SERVICE BULLETIN # 1088

SUBJECT FLYWHEEL AND PROTECTOR ASSEMBLY P/N 51203C

MODEL 1-70, 1-80, MC-10, DATE 3/30/60
44 and 55 Series

FIGURE 1

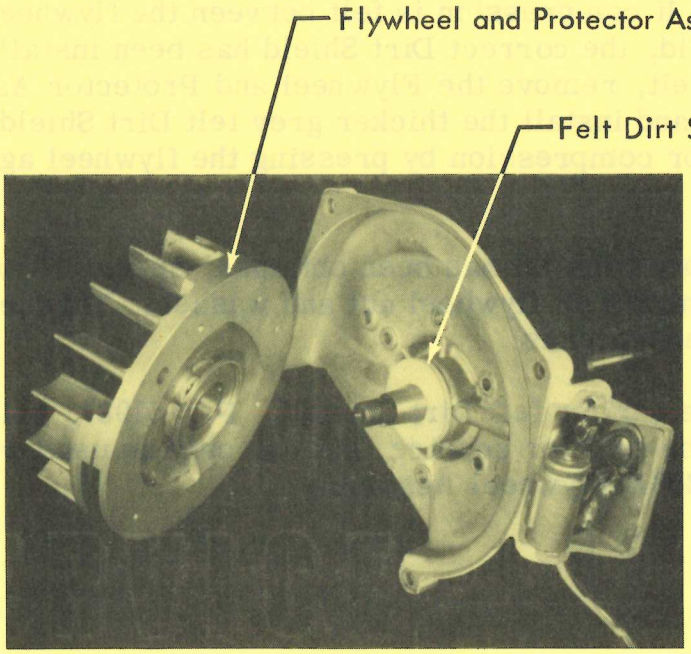
To provide a more efficient way to keep dirt from the breaker points push rod and reduce push rod wear, a new Flywheel and Protector Assembly, P/N 51203C, is available for service replacement on the models listed above. The new Flywheel and Protector Assembly replaces flywheel assembly, P/N 51203B.

The Protector on the new Flywheel and Protector Assembly is designed to keep sawdust from the push rod area and to provide a compression fit for the felt Dirt Shield. (Figure 1).

Two new felt Dirt Shields, P/N's 55584 and 55585, have been designed for use with the new Flywheel and Protector Assembly and replace earlier felt Dirt Shield, P/N 51987. For identification purposes, the new Dirt Shields are different in color. P/N 55584 Dirt Shield (.187 inch thick) is white, and P/N 55585 Dirt Shield (.250 inch thick) is grey.

To determine the correct Dirt Shield, first, install the white felt Dirt Shield (P/N 55584) on the crankshaft. Place the Flywheel and Protector Assembly on the crankshaft and press the flywheel firmly against the Dirt Shield. If compression is felt between the flywheel protector and the Dirt Shield, the correct Dirt Shield has been installed. If no compression is felt, remove the Flywheel and Protector Assembly and the Dirt Shield, and install the thicker grey felt Dirt Shield (P/N 55585). Test again for compression by pressing the flywheel against the Dirt Shield.
